COUNTY OF YORK

MEMORANDUM

SUBJECT: Appeal of Certificate of Appropriateness for Application No. HYDC-118-16, Grace Episcopal Church

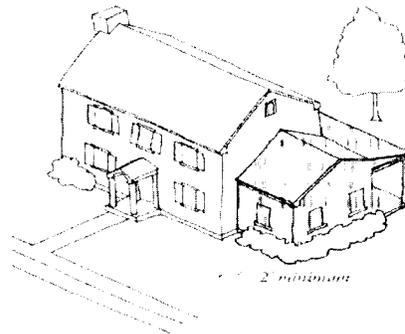
The Design Guidelines state that "additions should be located at the side or rear of existing construction...[and]... **be set back from the corner(s) of existing construction by a minimum of one (1) foot**" (emphasis added). This building offset is intended to preserve the character of the Yorktown Village architecture and to clearly differentiate between not only historical and newer construction, but also to inform the public as to the difference between legacy and new construction, even in the case of *noncontributing* structures such as Riverview.

Grace Church desires to have the HYDC's condition requiring an offset overturned. The church contends that there is no need for the offset since there are no occupied properties to the east and there would be limited visibility of the addition from the north (Water Street) and west (neighboring residential properties). Also, the church notes that including the offset would require re-engineering of the building plans and additional structural changes, both adding to the cost of the project, and that it would compromise interior functionality.

This was the first proposal for an end-extension building addition that has been reviewed in the 12-year history of the HYDC. While the Guidelines are, in fact, "guidelines", one of the *Five Principles* upon which they are based is "*Let what is old be dominant over the new*" (page 21, Yorktown Design Guidelines) and the architectural premise of having additions be subordinate to the main block of an existing building is demonstrated by the following diagram shown on page 84 of the Guidelines document.

With respect to this case, I understand the HYDC's interpretation and application of the guideline calling for an offset in the wall plane of the proposed addition to the eastern end of the structure. However, while including that offset would provide symmetry with the offset of the existing wing on the western end of the structure, given that "Riverview" is a non-contributing structure per the Guidelines definitions I do not believe the off-set is as necessary as it would be with a *contributing* or *pivotal* structure (the terms used for structures constructed before 1946). Moreover, I believe, as the church notes in its appeal, that the limited visibility of the addition, both currently and perhaps more so if plans for new construction behind the Pub ever materialize, provides rationale for eliminating the off-set requirement. Accordingly, I recommend that the HYDC's decision concerning the need for an off-set (setback) between the front façade of the existing structure and the front façade of the proposed addition be overturned.
